Re: Consistency Determination of the Dominican Valley Housing Project Development Application (PLAN23-081; ED23-062; TS23-001) at APN 015-163-03

Date: August 12, 2024
To: Sarah Teplitsky, City of San Rafael
From: Neil Smolen & Bob Grandy, Fehr & Peers
Subject: **Dominican Valley TIS Peer Review**

SUBJECT: PLAN23-081 – Dominican Valley – 4th Review

TENTATIVE MAP
DOMINICAN VALLEY SUBDIVISION
APN: 015-163-03
CITY OF SAN RAFAEL, MARIN COUNTY, CALIFORNIA
APRIL 2024

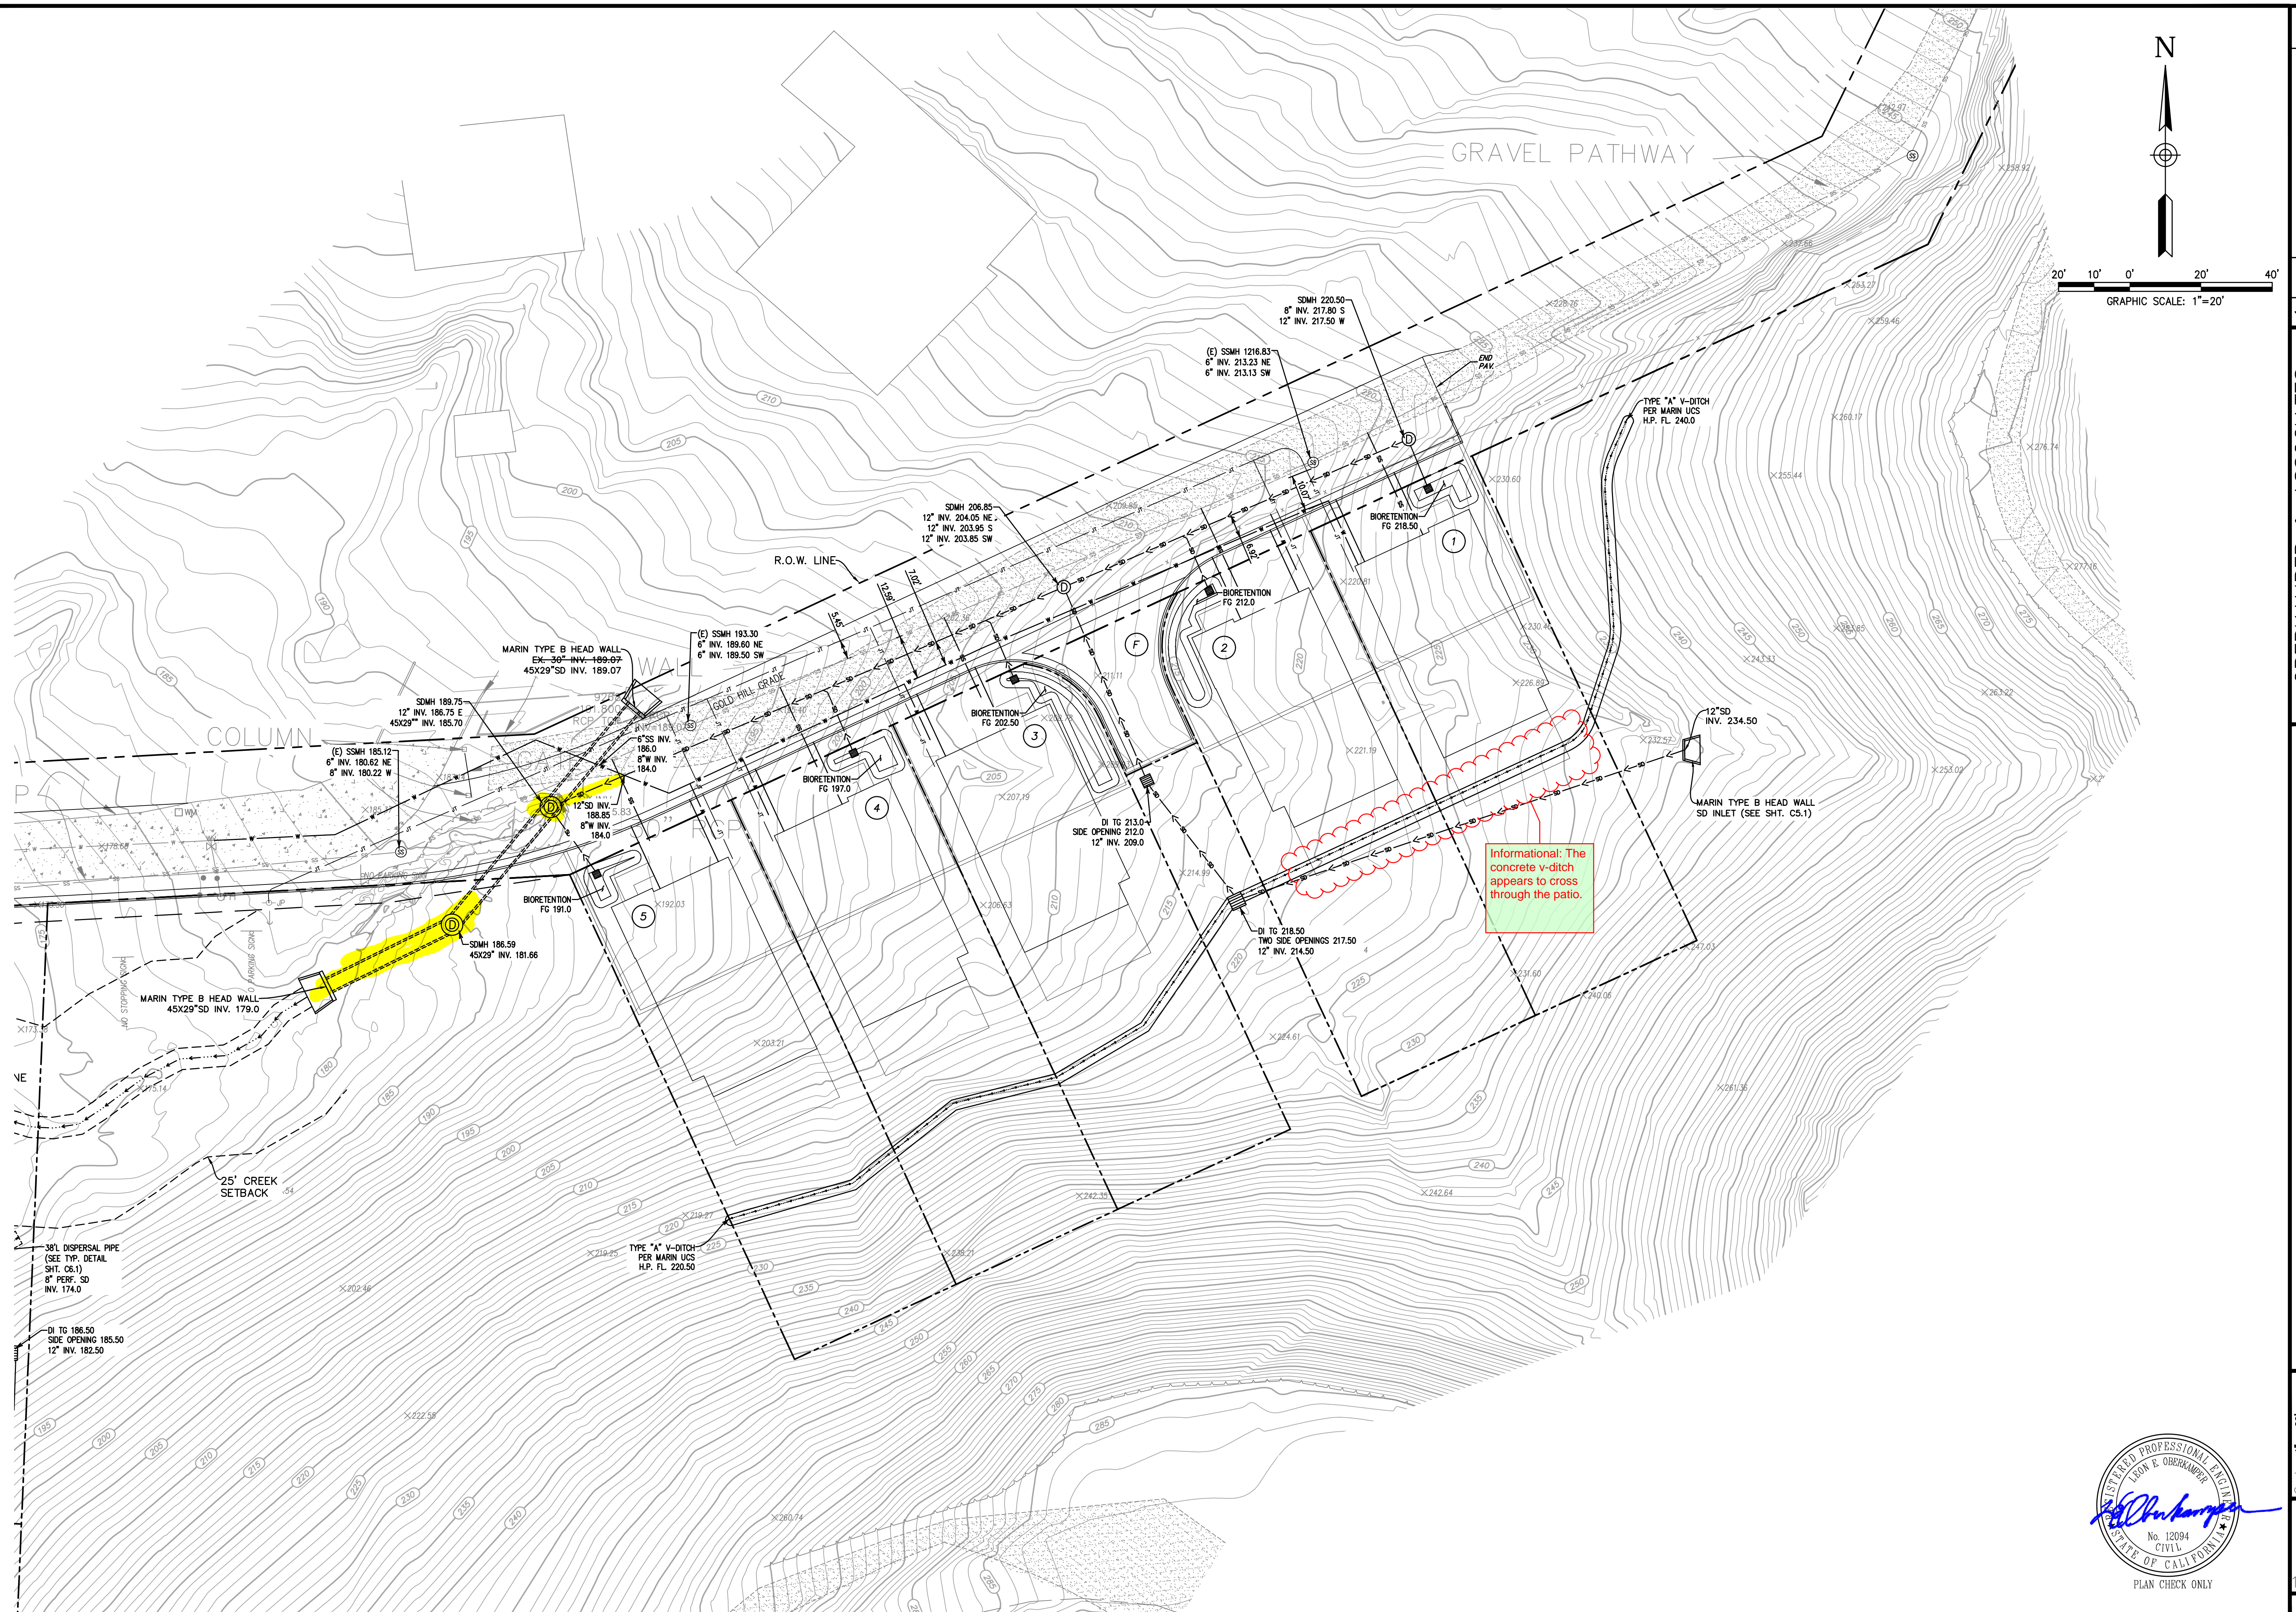
- 1. Preliminary Drainage and Utility Plan - Sheet C6.1:
 - a. The storm drain fronting lots 15 through 31 was moved to the opposite side of the street. There are 16 direct connections to the public storm drain. The City will not accept this many lateral connections to a public storm drain. The lateral connections from the bioretention inlets shall be combined using an on-site storm drain, which can then be connected to the public storm drain through a single storm drain lateral and structure such as a catch basin or storm drain manhole.

C7.0

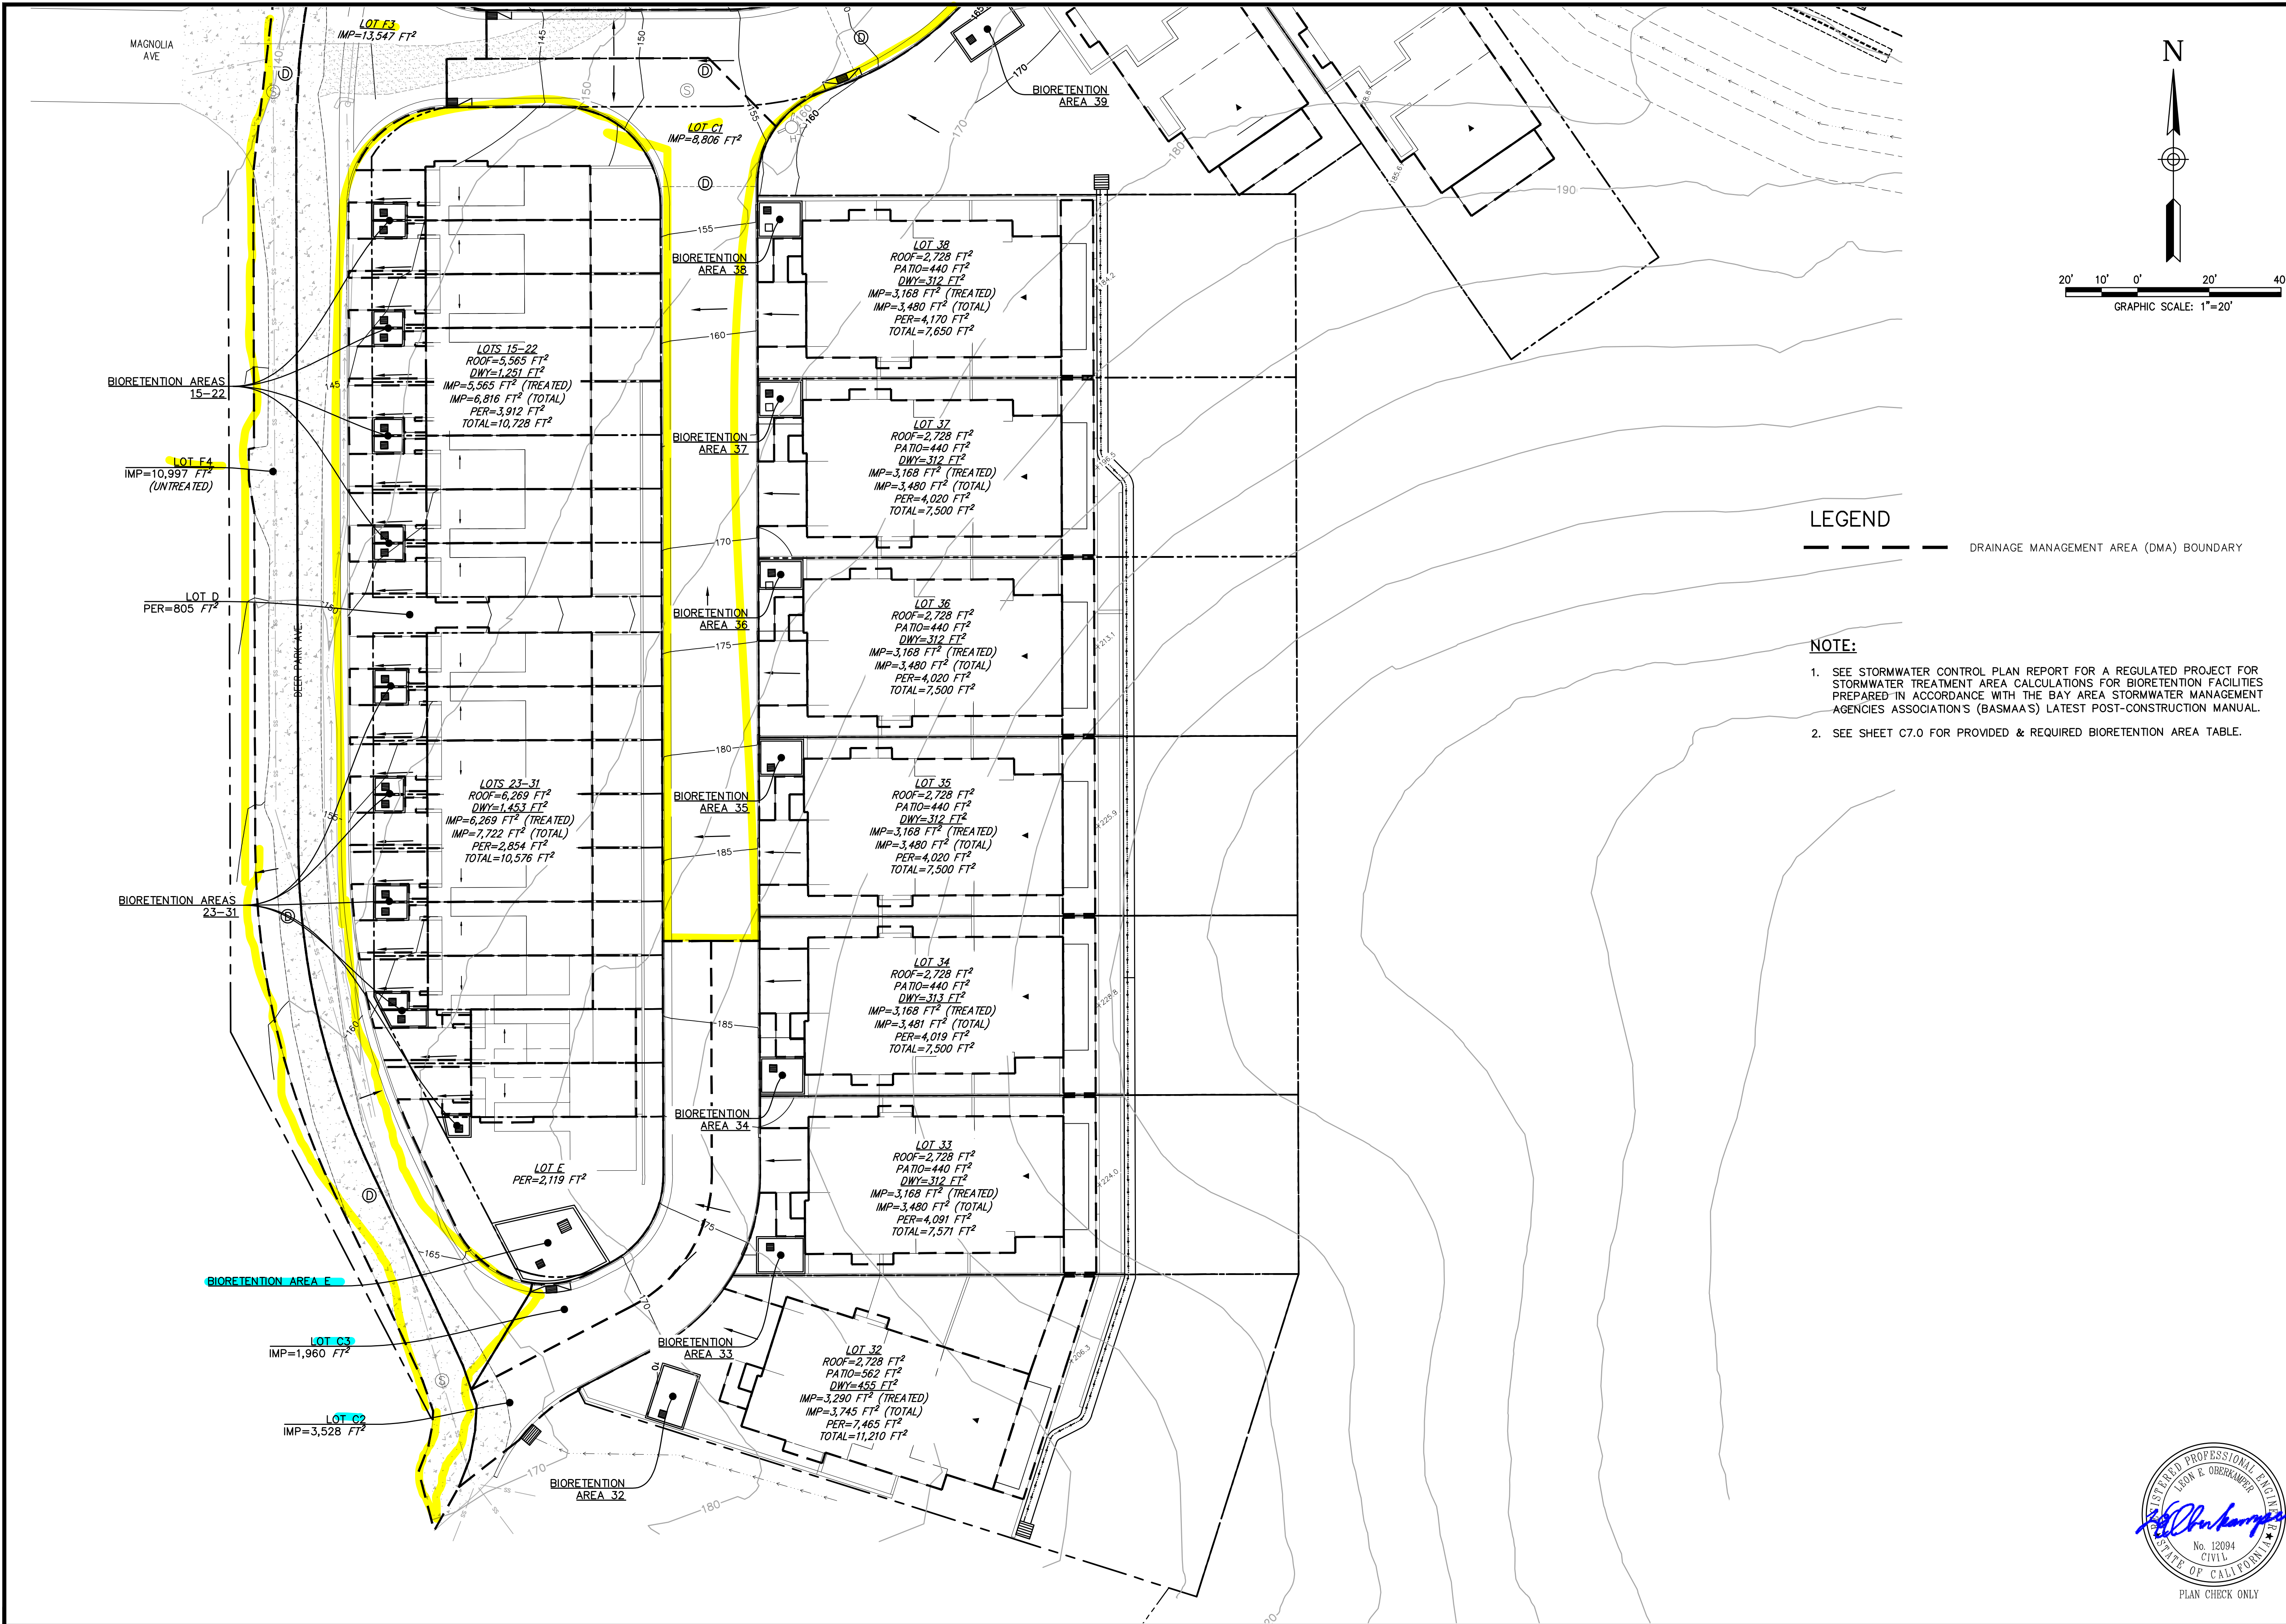
- 2. Preliminary Stormwater Control Plan - Sheet C7.0:
 - a. Per BASMAA Stormwater Control Plan Checklist, Contents of Exhibit, Page 3-2, the entire site shall be divided into separate Drainage Management Areas (DMA). Each DMA shall have a unique identifier. Use DMA labels (not lot labels) and linework that clearly delineate the entire limits of the DMA. For example, at lot 1, rename it to DMA 1 instead of referring to the lot number. Lot 1 also includes landscape that drains to the

lot 1 bioretention area and should be included in a separate DMA. Per BASMAA Page 4-1, each DMA must contain only one type of surface.

- b. All areas draining to a stormwater facility needs to be included as a DMA and used in the sizing calculations. Refer to BASMAA Table 4.1 for the runoff factors for various surfaces.

- c. On Sheet C7.0, clearly show the limits of the DMAs. Each DMA shall be labeled as DMA 1, DMA 2, DMA C1, etc. Where more than one DMA drains to a bioretention facility, show the total tributary area to that bioretention facility. For example, clearly show the boundary tributary to Bioretention Area B since it is made up of 7 DMAs.

- e. Bioretention B measures approximately 1,930 SF while the SWCP table states 2,500 SF is provided. Reconcile the discrepancy between the plans and the calculations and show the actual size of the required bioretention area as this may affect the site plan layout.

- f. Include a hatch that shows existing and proposed impervious areas tributary to the bioretention areas to improve the clarity of the exhibit.
